Lauer EIS

June 15, 1978

REPORT ON THE EXAMINATION OF PLANS AND SPECIFICATIONS
FOR THE LAUER LANDFILL AND SKI-HILL DEVELOPMENT PROJECT

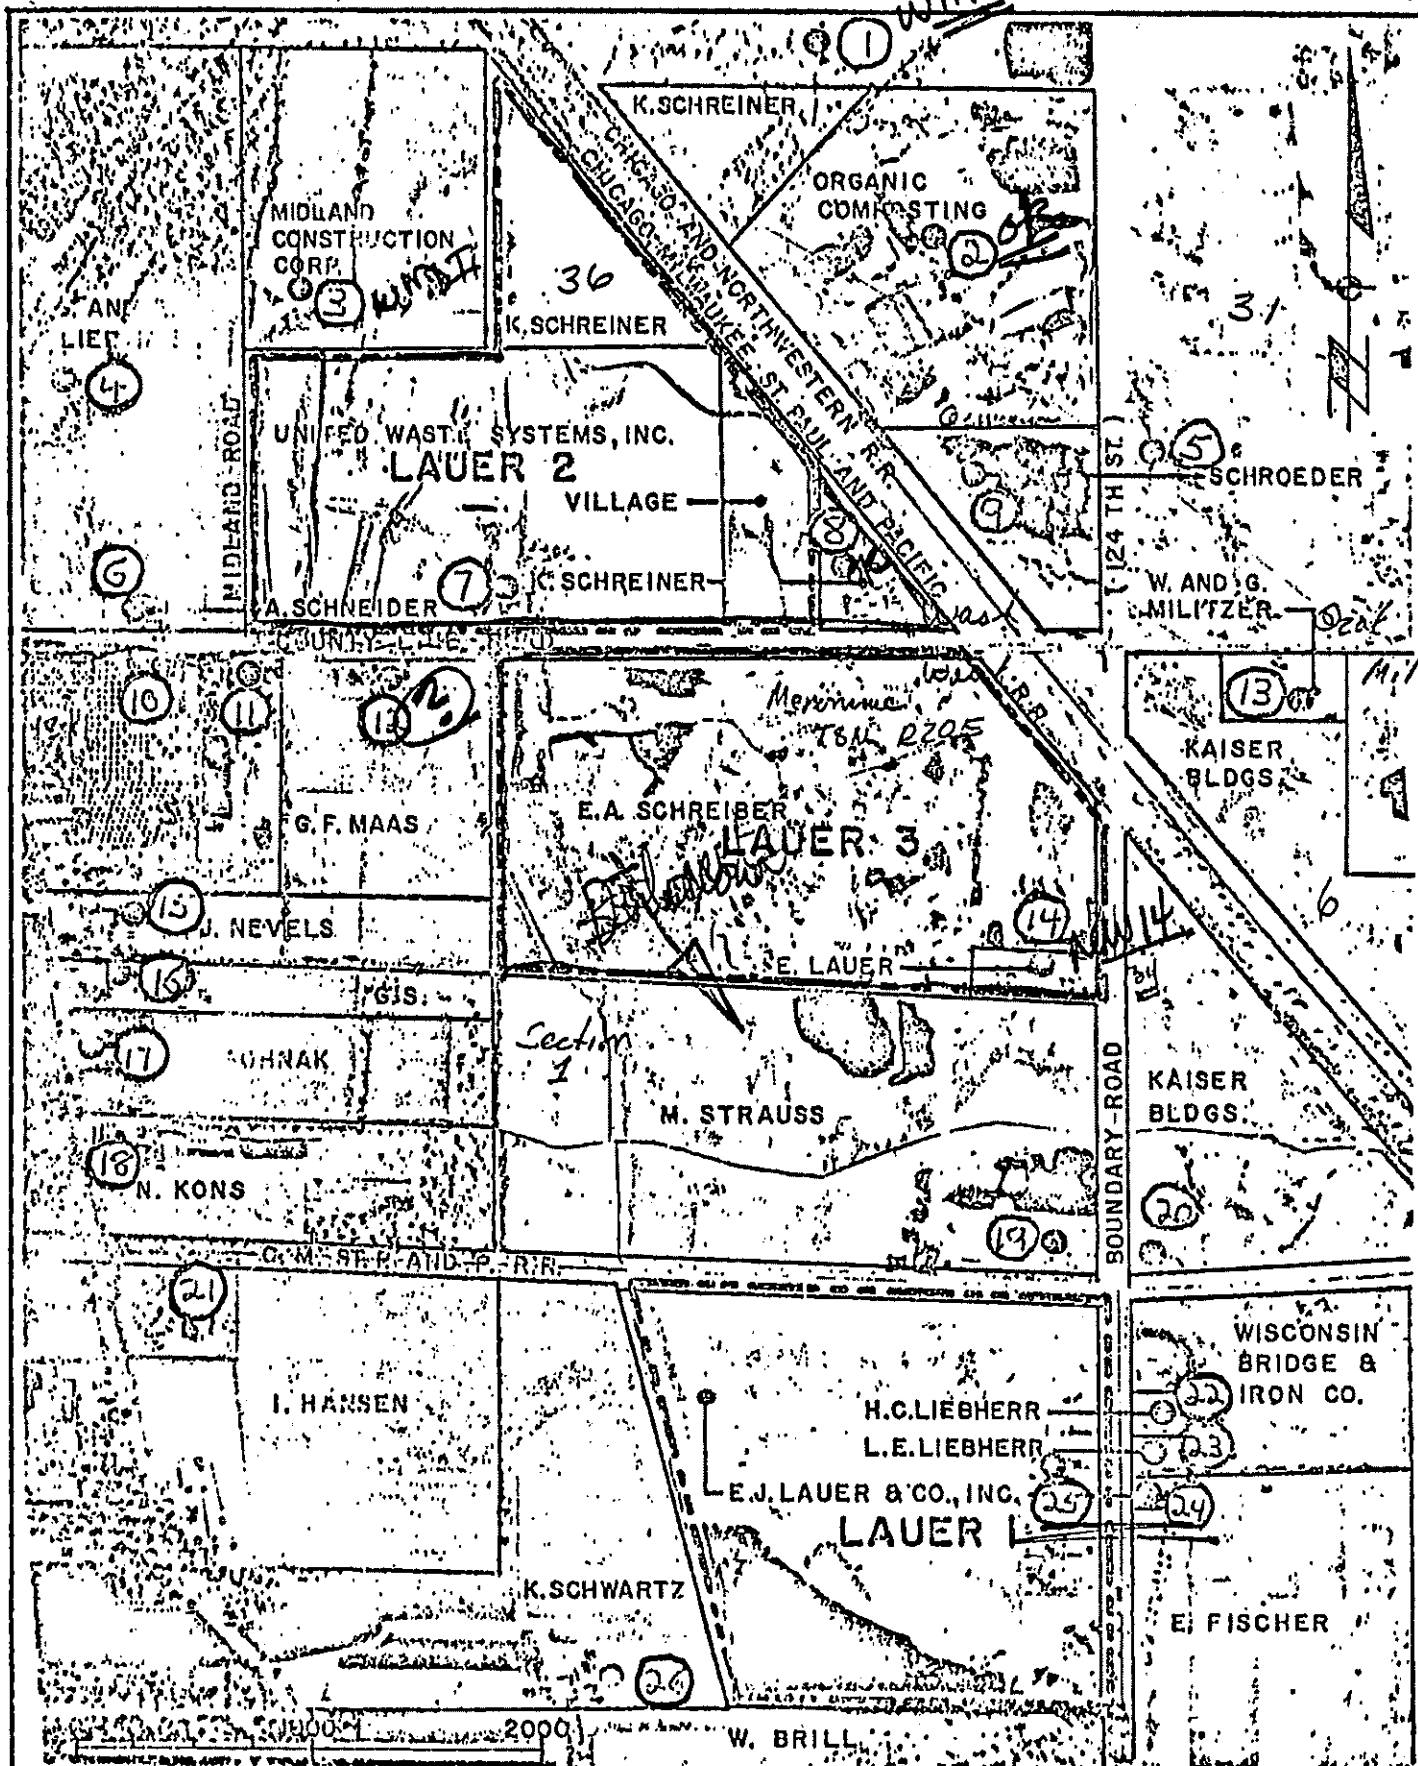
30. The following proposed leachate head maintenance level shall be monitored and maintained within the Lauer 2 and Lauer 3 fills respectively. 770 MSL Lauer 2 easterly 775 MSL Lauer 2 westerly, 755 MSL Lauer 3. If during the operations of these areas the required maintenance levels cannot be maintained by recirculation of leachate back into the fill, leachate will be required to be removed from that area and treated at the southwest sewage treatment plant. Records should be kept on the amount of leachate handled and on the levels of leachate within those sumps from this point forth. Leachate levels shall be recorded from each sump on monthly basis. The water quality shall be performed on a quarterly basis with a quarterly sampling.

The results of the leachate level monitoring and water quality results on the leachate shall be submitted on a quarterly basis in conjunction with the water quality monitoring results.
